**Request for Modification No. 23-024 to Resource Conservation and Recovery Act (RCRA) Facility Operating Permit, Sandia National Laboratories, New Mexico, Environmental Protection Agency Identification Number NM5890110518, March 2023**

Subject: Request for Modification No. 23-024 to Resource Conservation and Recovery Act (RCRA) Facility Operating Permit, Sandia National Laboratories, New Mexico, Environmental Protection Agency Identification Number NM5890110518

**Certification Statement  
Revisions to RCRA Facility Operating Permit  
Long-Term Monitoring and Maintenance Plan for the Mixed Waste Landfill  
Permit Modification 23-024**

**Summary of Changes to RCRA Facility Operating Permit  
Long-Term Monitoring and Maintenance Plan for the Mixed Waste Landfill  
Permit Modification 23-024**

~~MWL-MW4~~

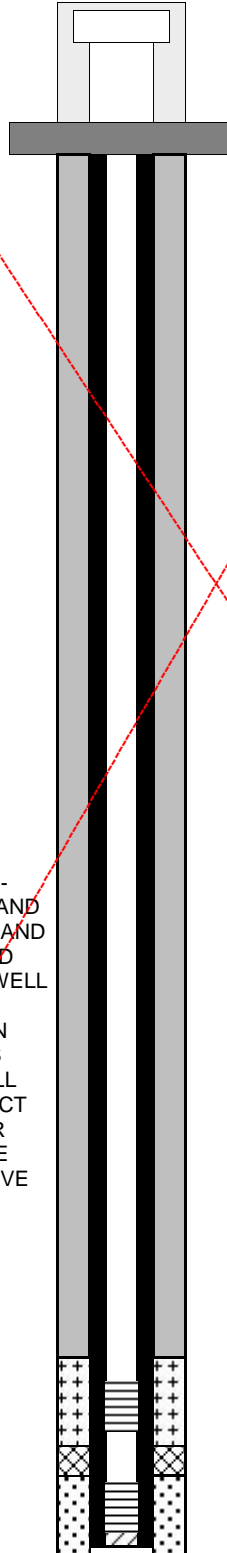
| Item | Permit Location(s)  | Current Language  | Proposed Language   | Explanation for Change   | Modification Class Rationale  |
|------|---|---|---|--|---|
| 10   | LTMMMP Appendix H Mixed Waste Landfill Well Database Summary Sheets | <i>Cover pages and well diagram</i>   | <i>Cover pages and well diagram</i>   | Revised to remove references to MWL-MW4.   | <i>Class 2 modification.</i><br>Change to number of wells of the groundwater monitoring system<br><br>20.4.1.900 NMAC, 40 CFR 270.42 Appendix I, Modification C.1 |

**Figure 3.5.1-1  
Mixed Waste Landfill Groundwater Monitoring Wells**

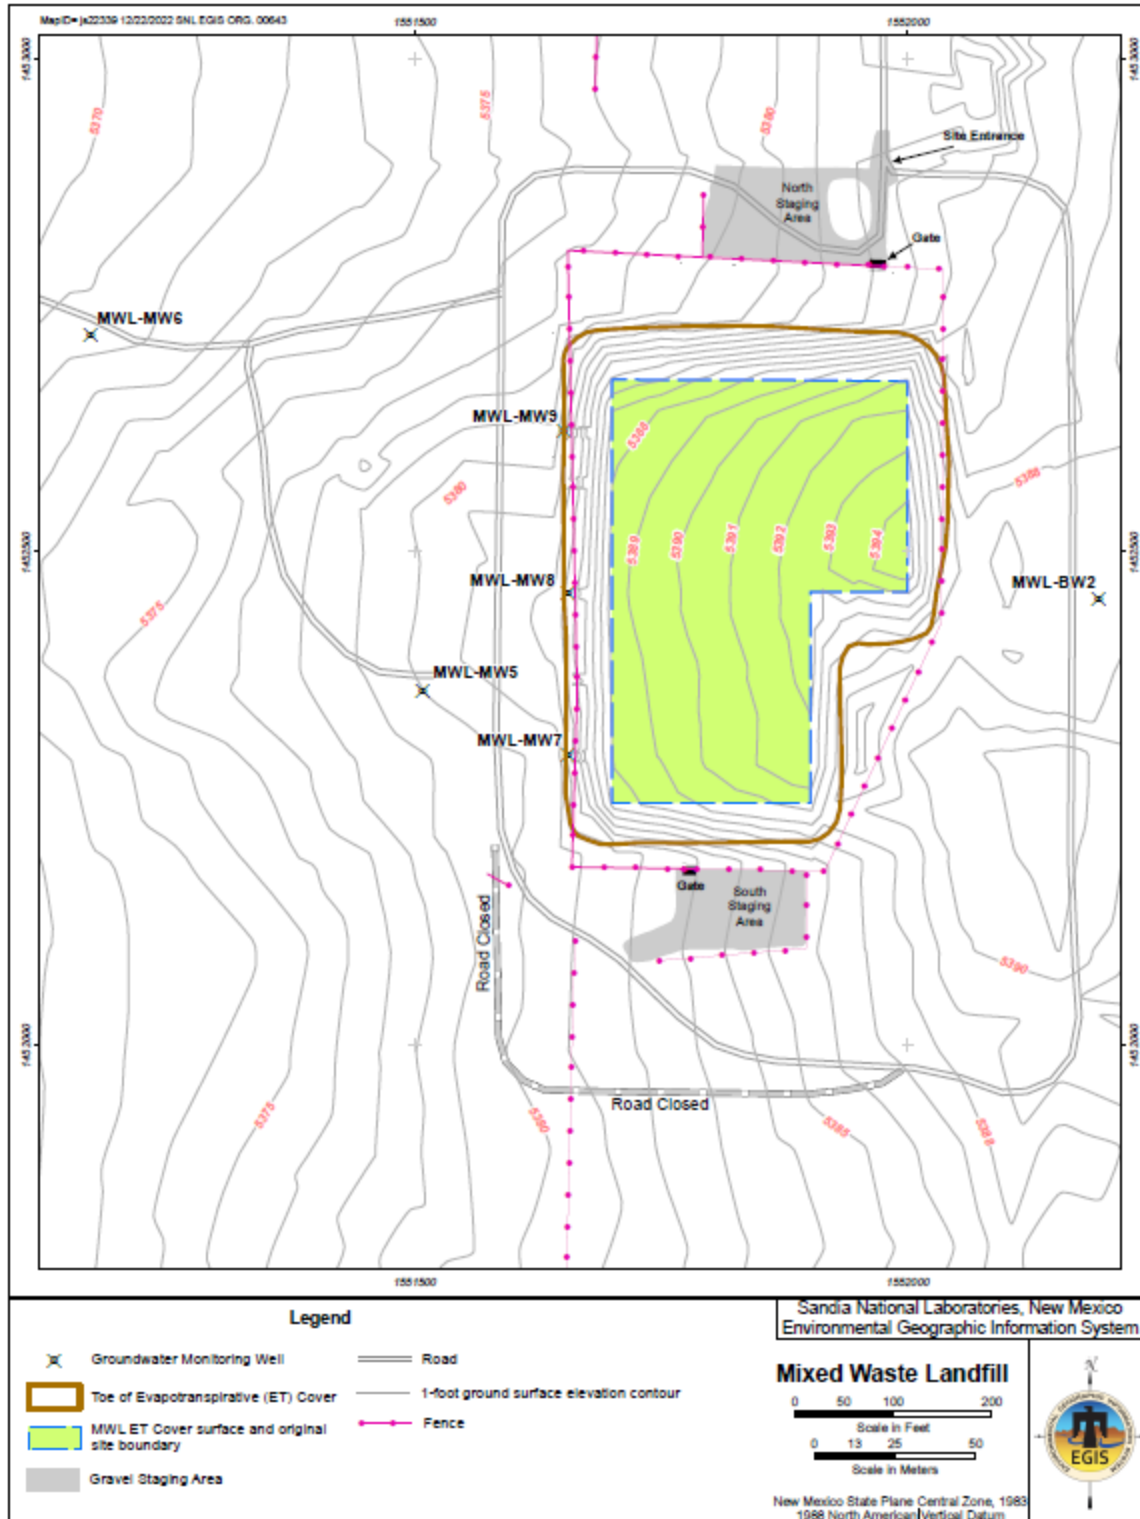
| Item | Permit Location(s)  | Current Language   | Proposed Language  | Explanation for Change   | Modification Class Rationale   |
|------|---|--|--|--|--|
| 6    | LTMMMP<br>Section 3.5.1,<br>Figure 3.5.1-1,<br>Page 3-17                | Mixed Waste Landfill Groundwater<br>Monitoring Wells   | <i>Revised figure</i>  | Figure revised to remove MWL-<br>MW4.  | <i>Class 2 modification.</i><br>Change to number of wells<br>of the groundwater<br>monitoring system<br><br>20.4.1.900 NMAC,<br>40 CFR 270.42<br>Appendix I,<br>Modification C.1 |

**Figure 2. Mixed Waste Landfill Groundwater Well Locations and Potentiometric Surface Map**  
Monitoring well MWL-MW4 is proposed for decommissioning and circled in red.

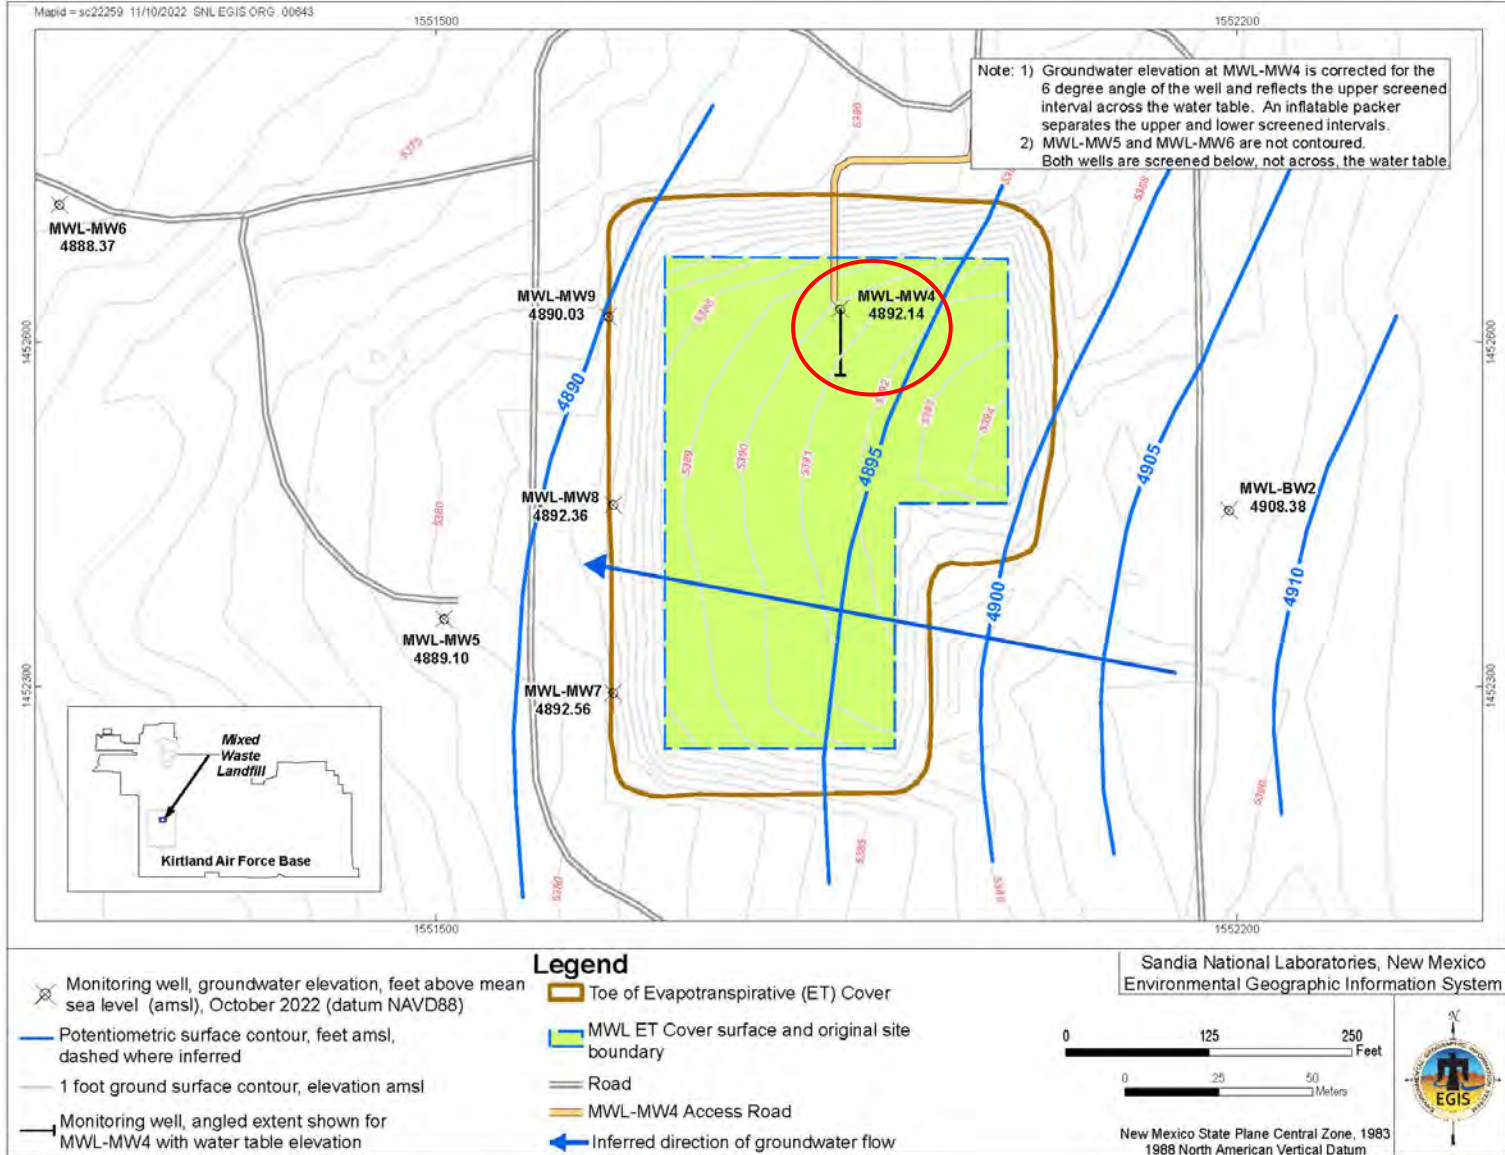
Groundwater monitoring well MWL-MW4 is proposed for decommissioning in this Work Plan. This well is located in TA-III, inside the fenced area of the MWL, on DOE-controlled property within Kirtland Air Force Base property (Figures 1 and 2). The well completion diagram for this monitoring well is provided in Attachment 1 and the pertinent well completion information is summarized in Table 1 below.
